Request for Additional Information No. 167, Supplement 3

U. S. EPR Standard Design Certification

Docket No. 52-020

Application Section: FSAR Ch 15

Figure 15.6.5-29-1—Elevation View of the U.S. EPR Crossover Pipe

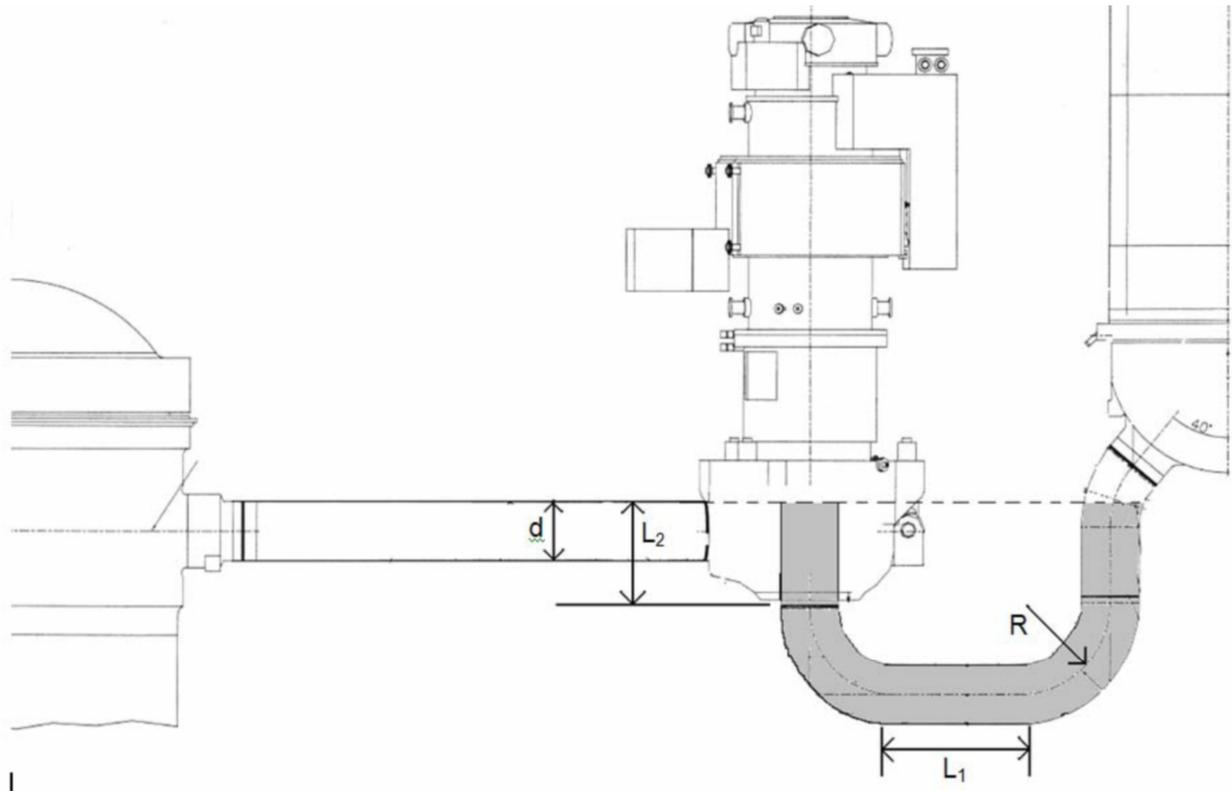
The report did not present results that describe possible accumulation of condensate in the steam generator (SG) exit chamber and the attached cold leg nozzle/piping nor did it consider the liquid conditions in the pump discharge pipe. Provide an assessment of the total amount of condensate generated in each loop.

Four SBLOCAs (1.5 inch – 4 inch cold leg breaks) were analyzed to evaluate the key characteristics during the boron dilution event. The automatic depressurization and operator-initiated continued depressurization reduces SG pressure below the RCS pressure. The amount of time that it takes for the SGs to depressurize below the RCS pressure increases with increasing break size, because the RCS pressure drops as the break size becomes larger. At this point, and until the safety injection flow refills the RCS, the primary side is cooled and some of the steam condenses in the SG and collects in the crossover pipe. The relative elevations of the components downstream of the downside SG tubes limit the collection of condensate. Figure 15.6.5-29-1 shows the relative elevations of the SG, reactor vessel, cold leg, reactor coolant pump (RCP), and crossover leg. As shown, the SG outlet plenum is above the top of the cold leg, and can not fill with deborated water without draining into the cold leg. Figure 15.6.5-29-2 shows the internal configuration of the impeller discharge of the RCP as being close to the top of the cold leg (within approximately 3 inches). This geometry allows a maximum deborated fluid volume as the sum of the following (shown as the shaded area in Figure 15.6.5-29-1):

This volume represents the maximum deborated fluid volume that can build up before draining into the reactor vessel until the system refill begins to raise the level in the RCS. The volume of the shaded area in Figure 15.6.5-29-1 is 171 ft³. To account for any small volumes of deborated fluid accumulation in the bottom of the pump casing or SG outlet plenum, the calculated deborated fluid volume is increased by 25 percent to be 216 ft³. The PKL test had an equivalent volume of 388 ft³, but in the PKL tests, due to pressure limitations of the facility, the slugs for the SBLOCA tests could not be formed under the same conditions as in the PWR transient. Instead, a large part of the slug generation had to be accomplished in a conditioning phase at a constant pressure. The PKL volume was conservatively maximized to fill the entire PKL loop seal, which is deeper than the U.S. EPR crossover pipe. In the three S-RELAP5 cases for which forward natural circulation ceased (2 inch – 4 inch), the crossover pipe was never completely filled prior to system refill.

Figure 15.6.5-34-1—Crossover Pipe Slug in Core as Flat Slab

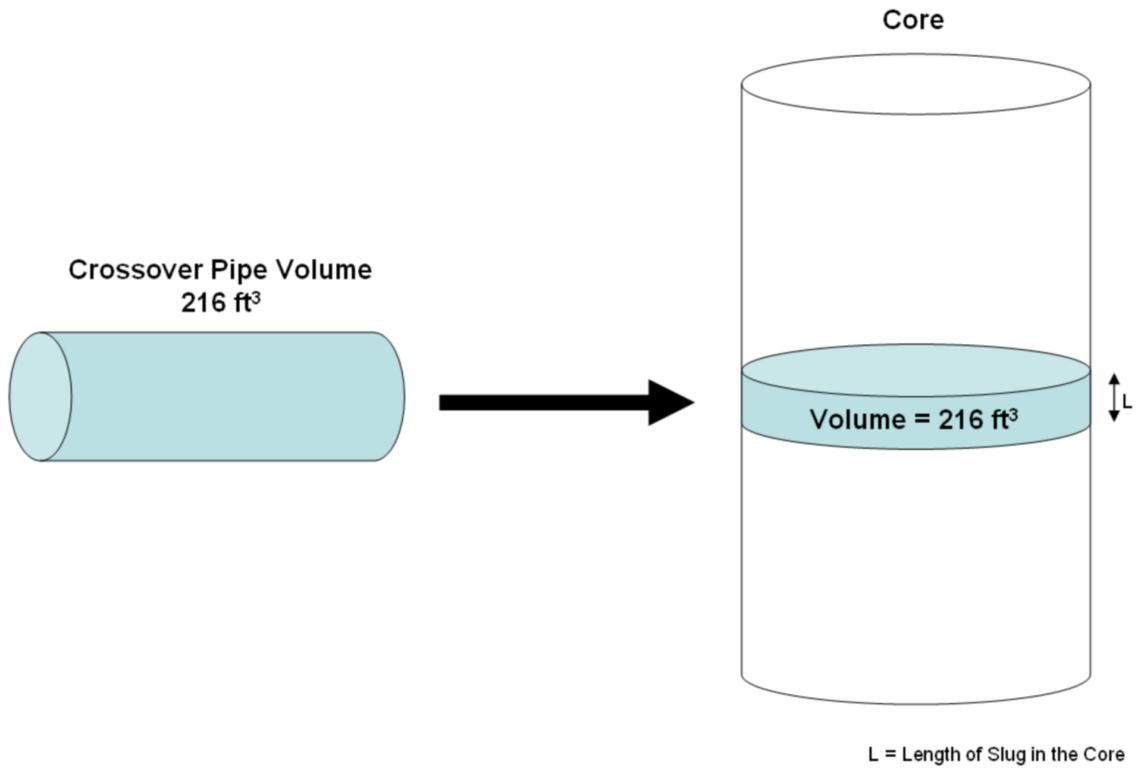
Explain the criticality consequences if a coherent slug of un-borated water of the quantity corresponding to the volume of a single crossover pipe were to be transported to the reactor vessel inlet by resumption of natural circulation.

The size of the slug was varied from 25 percent to 100 percent of the maximum deborated fluid volume (100 percent volume = 216 ft³, see RAI 15.06.05-29), and included a deborated slug that would occupy the full core (877.1 ft³). The slug was flattened, keeping the volume constant, so that it has the full flow area of the core (as shown in Figure 15.6.5-34-1). The location of the slug volume was also varied vertically within the core. The remainder of the core was assumed to be at a conservative concentration of 3000 ppm natural boron (the in-containment refueling water storage tank (IRWST) minimum boron concentration is 3235 ppm). The 18 month equilibrium cycle at the beginning of cycle with the slug located near the top of the core was found to be the most limiting condition. The resulting required concentration, as a function of slug vertical length, is given in Figure 15.6.5-34-2 and Table 15.6.5-34-1, and covers a slug vertical length that varies from a full core length down to 10.2 inches. Each boron concentration value in Figure 15.6.5-34-2 and Table 15.6.5-34-1 is the minimum natural boron concentration required when the slug is in the core, and includes an additional 100 ppm for conservatism. These analyses demonstrate that a 216 ft³ slug of water will require a minimum concentration of 1396 ppm as natural boron to maintain a one percent SDM.
